Franklin Municipal Planning Commission

Thursday, June 27, 2019

SOUTHBROOKE PUD SUBDIVISION
RESOLUTION 2019-40
ORDINANCE 2019-13
FRANKLIN MUNICIPAL PLANNING COMMISSION
06/27/2019

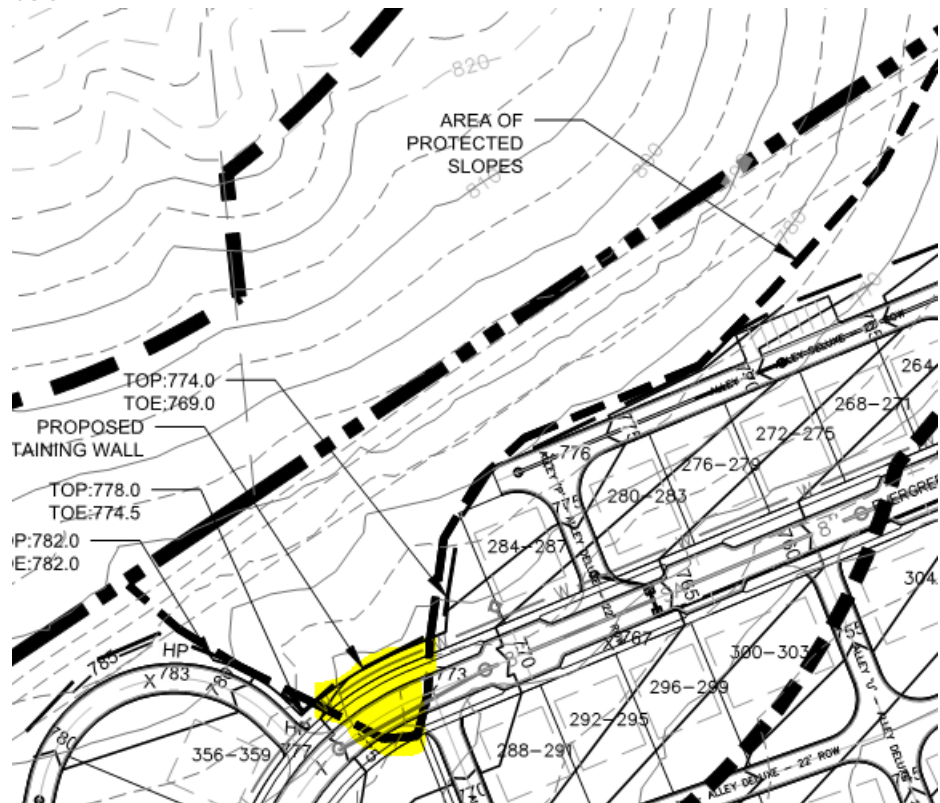
Applicant shall remove all proposed development, including streets, alleys, off-alley parking areas, and associated grading and retaining walls, from the "Area of Protected Slopes" identified on the Development Plan. One such area that persists is highlighted below:

165. Dead-End Streets/Alleys

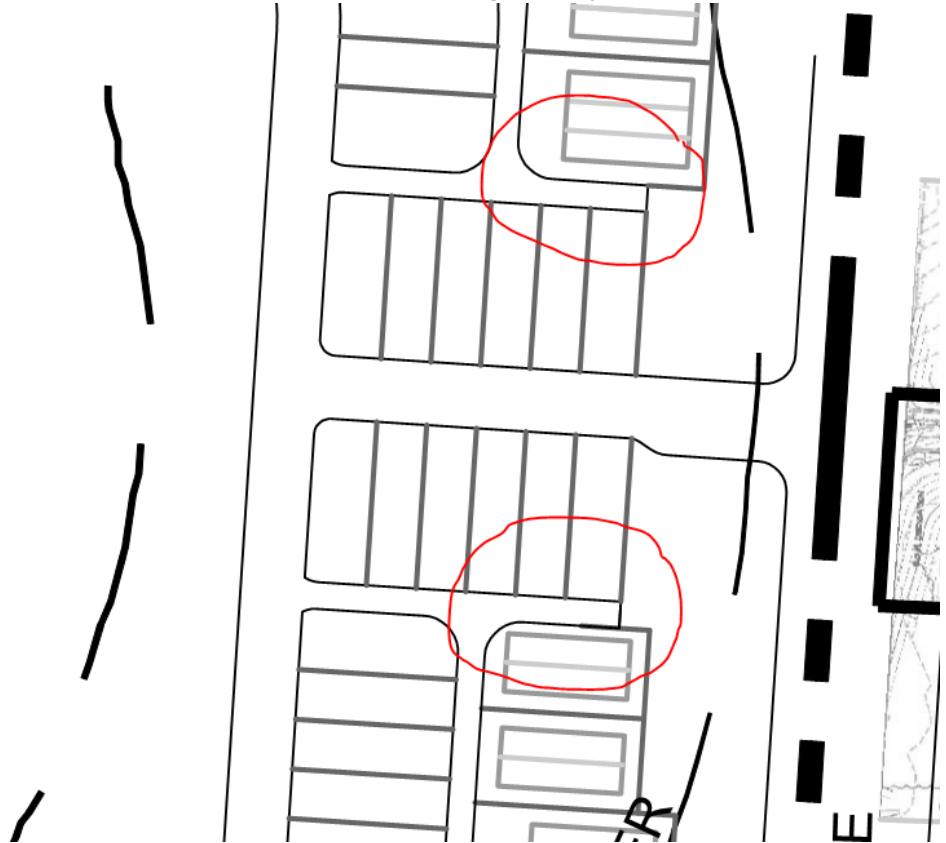
Section 2.3.7 of the Franklin Transportation & Street Technical Standards prohibits permanent dead-end streets/alleys without cul-de-sac designs. The dead-end alleys shall be removed and connected back to the right-of-way.

jimmy.wiseman@franklinton.gov Comment addressed. Thank you.

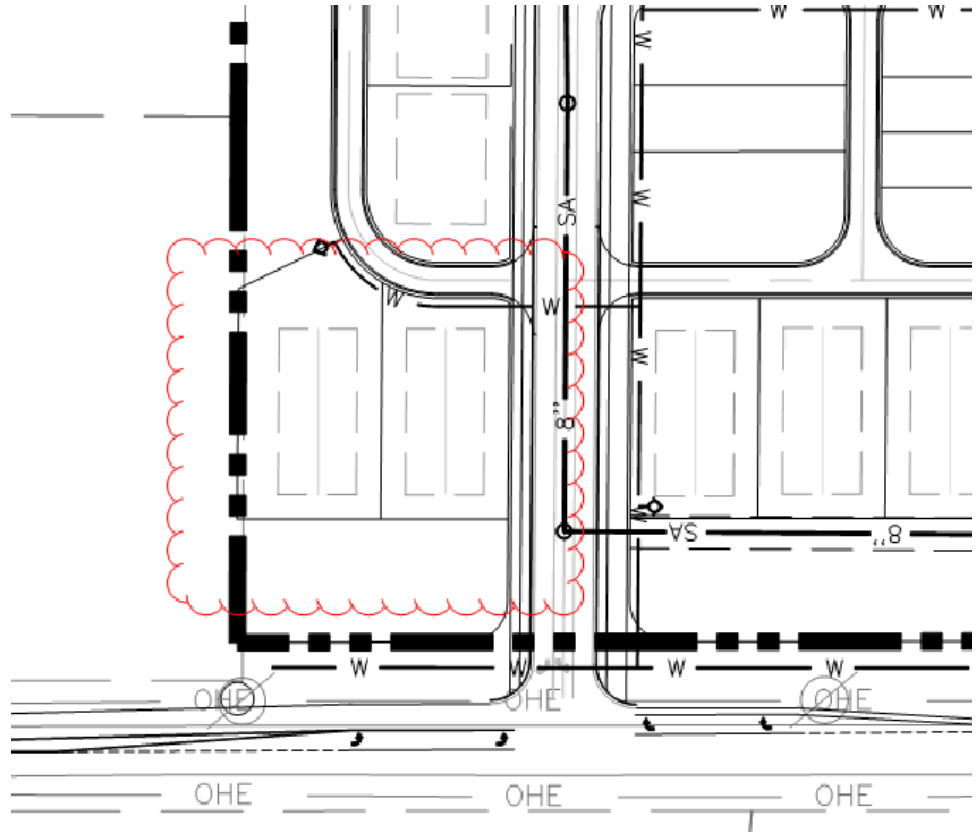
The applicant shall show how each lot will be served by sanitary sewer . The lot depicted below does not show sanitary sewer service.

174. Sanitary sewer

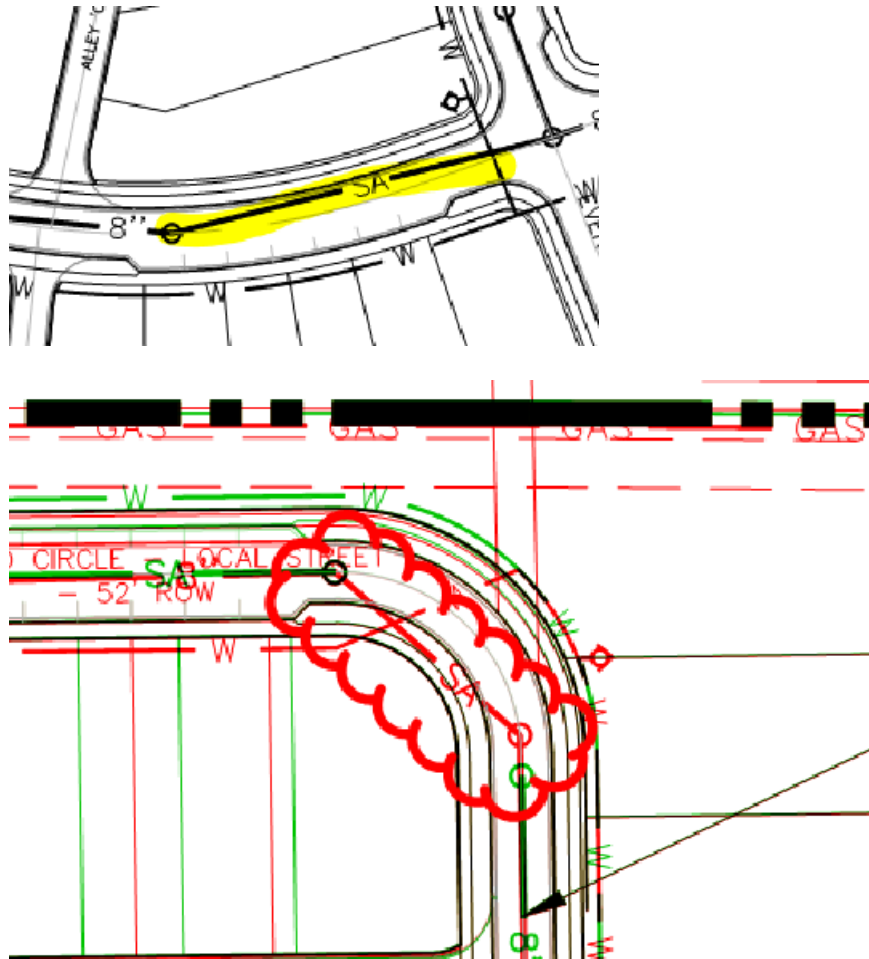
ben.mcneil@franklinton.gov The applicant shall show the proposed sanitary sewer mains in the center of the streets. There are numerous areas where the sanitary sewer main appears to be under curbs. The applicant shall revise.

OVERALL
DEVELOPMENT
PLAN
SHEET
C2.0
COF 6975

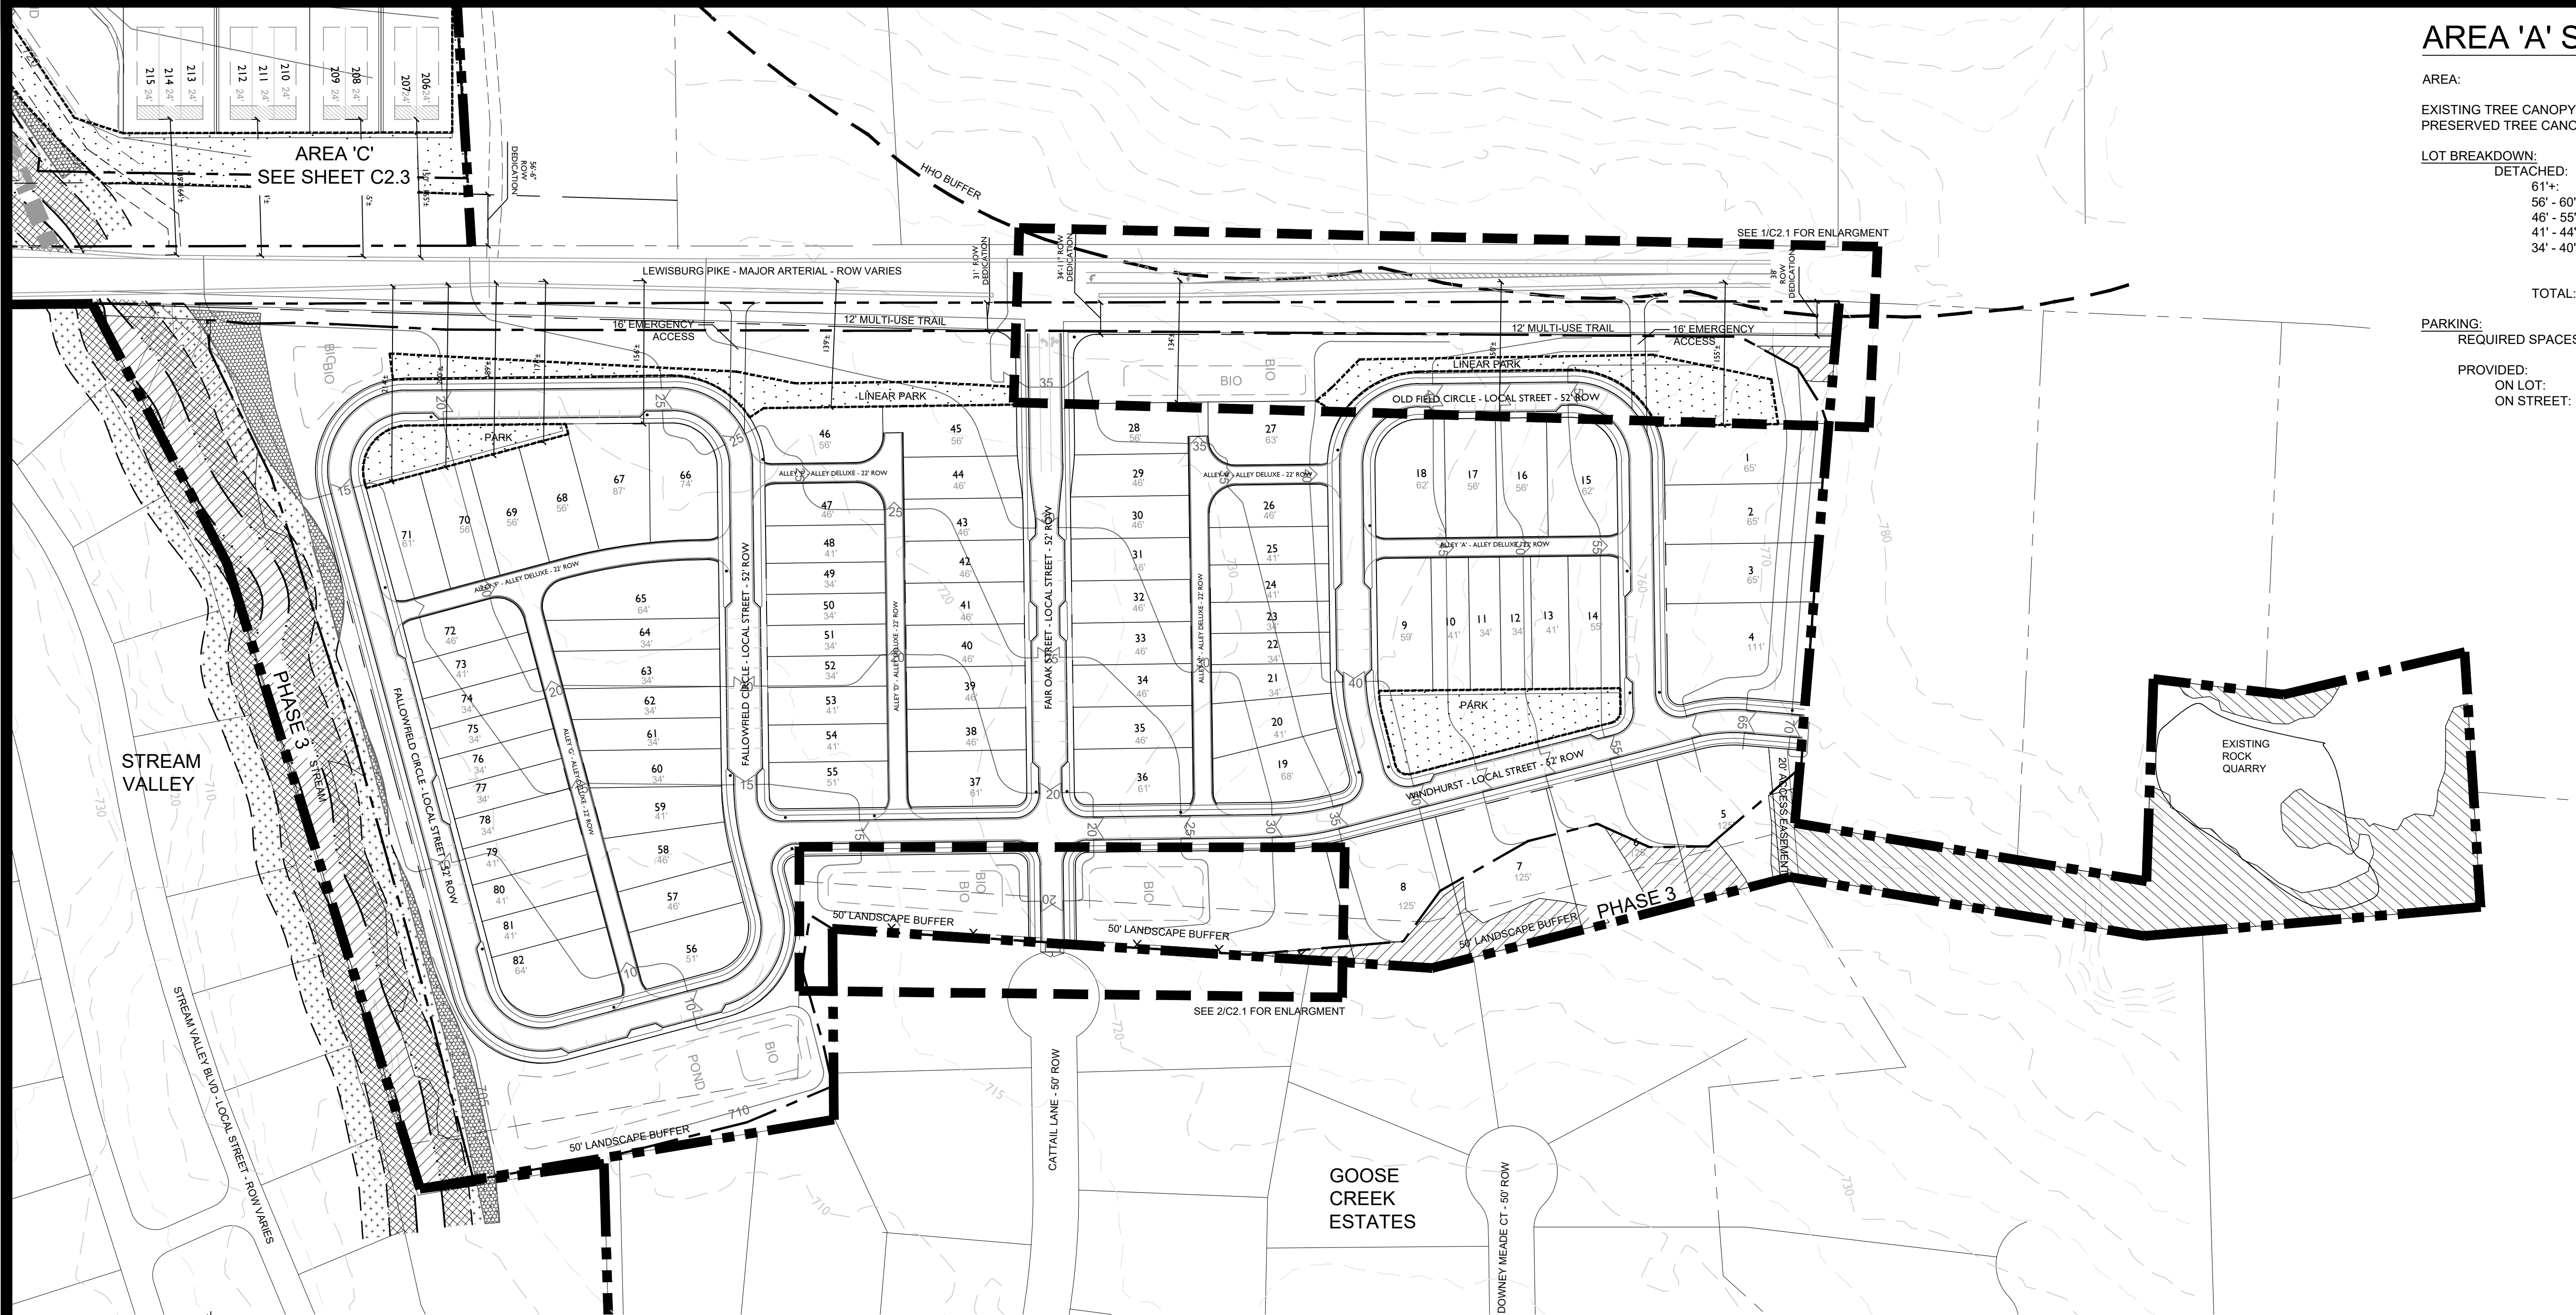
amy.diaz-barriga@franklin.tn.gov	On sheet C2.0, reference C2.12 next to the phasing list.
149. Buffers	
amy.diaz-barriga@franklin.tn.gov	The buffers in Section A are inconsistent from sheet to sheet. There should be an incompatible lot size buffer of 50' where the lots along the perimeter of the development are not within 75% of the existing adjacent lots.
greggamble209@gmail.com	All buffers are now 50'
amy.diaz-barriga@franklin.tn.gov	Label the buffer a class "c" incompatible use buffer, to be consistent in wording with the Zoning Ordinance.

180. tree canopy: number accuracy	
amy.diaz-barriga@franklin.tn.gov	Make the tree canopy preservation amounts match on sheet C2.0.
181. Addressing Manual update	
amy.diaz-barriga@franklin.tn.gov	Staff suggests an update to the addressing manual, to allow limited addressing off of alleys, when residential units front open spaces which are not perpendicular to ROW, or when residential units front open spaces which are perpendicular to arterial or collector roads.

FUTURE ARTERIAL STREET (LEWISBURG PIKE)

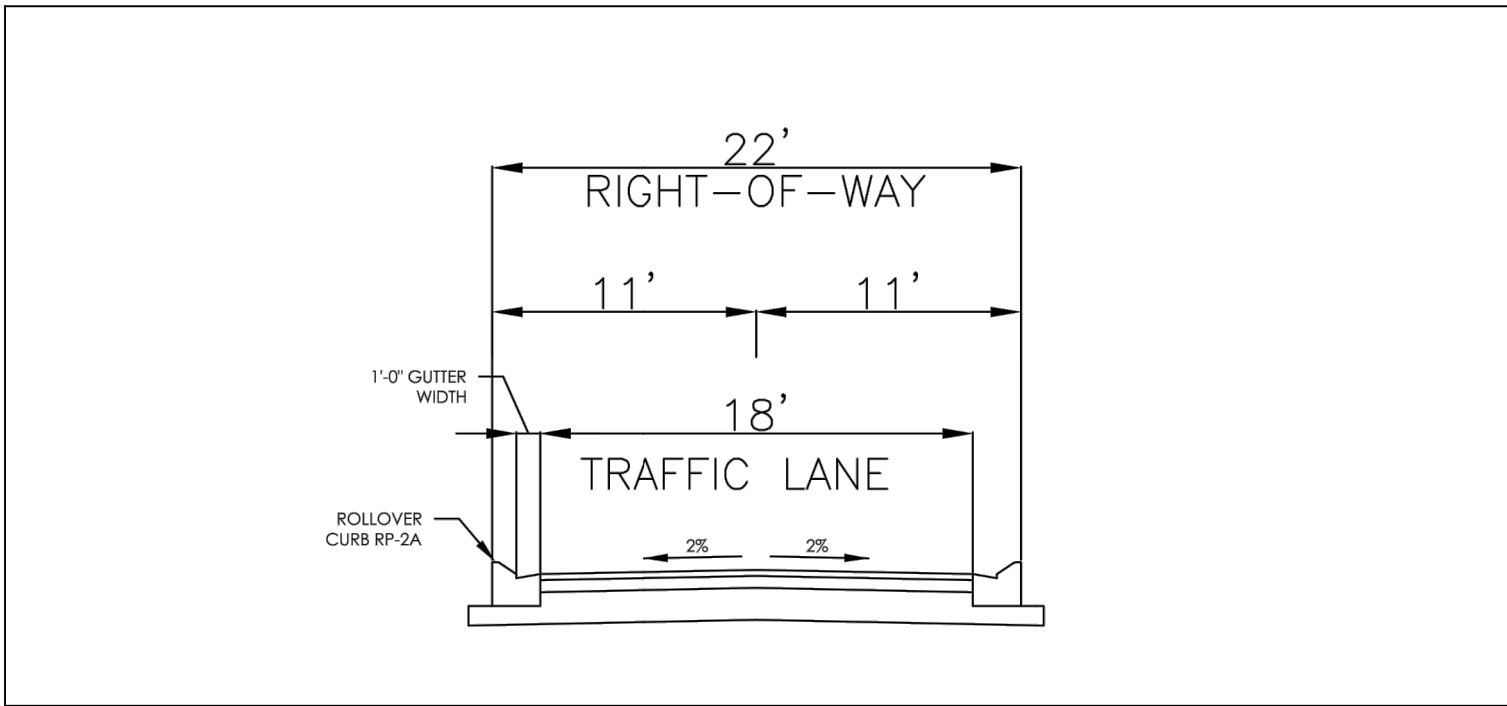
Applicant to revise Lewisburg Pike section (C4.6) and associated drawings to match that shown in the Comprehensive Transportation Network Plan and Street Specifications.
